# Work Order ID 98198

Item Name: Crosstube Assembly, Mid Aft

DART AEROSPACE LTD HAWKESBURY, ONTARIO, CANADA	
DRAWING NO. D206-667-247	REV. A SHEET 1 OF 4
TITLE CROSSTUBE ASS'Y (206L MID AFT)	SCALE NTS

DRAWING NO. D206-667-247	TITLE CROSSTUBE ASS'Y (206L MID AFT)	REV. A	<b>DART AEROSPACE LTD ENGINEERING ORDER</b>		D.E.O. NO. D206-667-247-A-1	SHEET NO. SHEET 1 OF 1	SCALE NTS
DRAWN <i>q2</i>	CHECKED <i>ASS</i>	MFG. APPR. <i>KD</i>	APPROVED <i>IMP</i>	DE APPR. <i>#</i>			
DATE 11.07.15	DATE 11.07.20	DATE 11.07.21	DATE 11/07/21	DATE 11.07.21

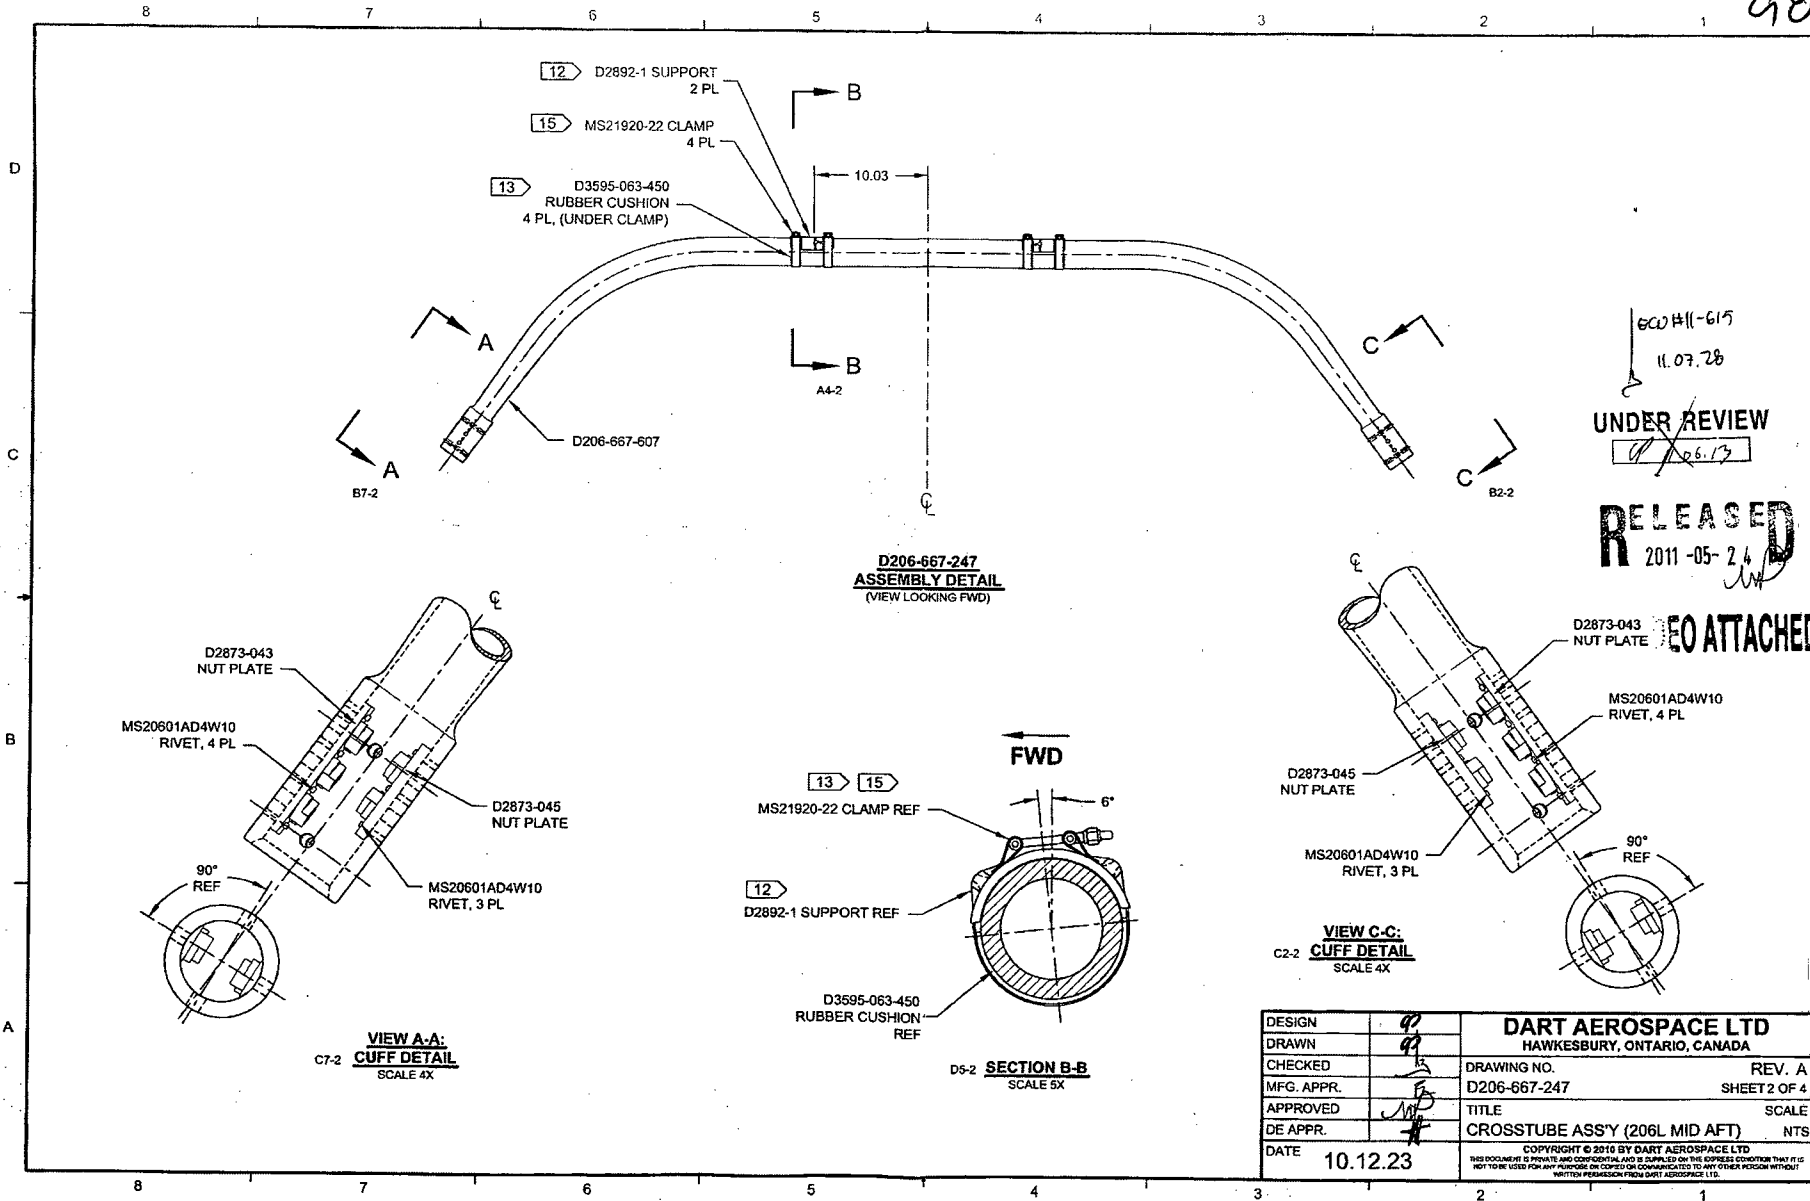
**PURPOSE:**

REPLACE MAGNOBOND WITH PROSEAL.

NOTE 12 &amp; 15, SHEET 1 IS AMENDED AS FOLLOWS:

IS:

Item	Qty -247	Part Number	Description
9	A/R	PROSEAL 890 B-2	SEALANT, AMS-S-8802 CLASS B-2

WAS:

9	A/R	MAGNOBOND 6398	ROCKWELL SPECIFICATION RBO-120-023 ADHESIVE (TEXTRON/BELL SPEC. 299-947-100, TYPE II, CLASS 2 ADHESIVE)
---	-----	----------------	---

IS:

- 12) TO INSTALL D2892-1 SUPPORT: ABRASE MATING SURFACE OF SUPPORT AND CROSSTUBE WITH 180-GRIT SANDPAPER AND REMOVE RESIDUE WITH MEK (OR EQUIVALENT). APPLY A 0.04" TO 0.07" THICK LAYER OF PROSEAL 890 CLASS B-2 (OR AMS-S-8802 CLASS B-2) SEALANT TO MATING SURFACE OF SUPPORT.
- 15) TORQUE CLAMPS 80 TO 100 IN-LB. ENSURE AT LEAST 1.5 THREADS SHOWING IN SAFETY AND THAT NUT HAS NOT BOTTOMED-OUT AFTER TORQUING. **PRIOR TO PACKAGING, RE-CHECK TORQUE ON CLAMPS AFTER PROSEAL 890 SEALANT HAS CURED FOR 72 HOURS.**

WAS:

- 12) INSTALL D2892-1 SUPPORT USING 0.03" TO 0.06" THICK LAYER OF MAGNOBOND 6398 PER QSI 015. LET CURE FOR 12 HOURS AFTER INSTALLATION AND PRIOR TO PACKAGING.
- 15) TORQUE CLAMPS 80 TO 100 IN-LB. ENSURE AT LEAST 1.5 THREADS SHOWING IN SAFETY AND THAT NUT HAS NOT BOTTOMED-OUT AFTER TORQUING.
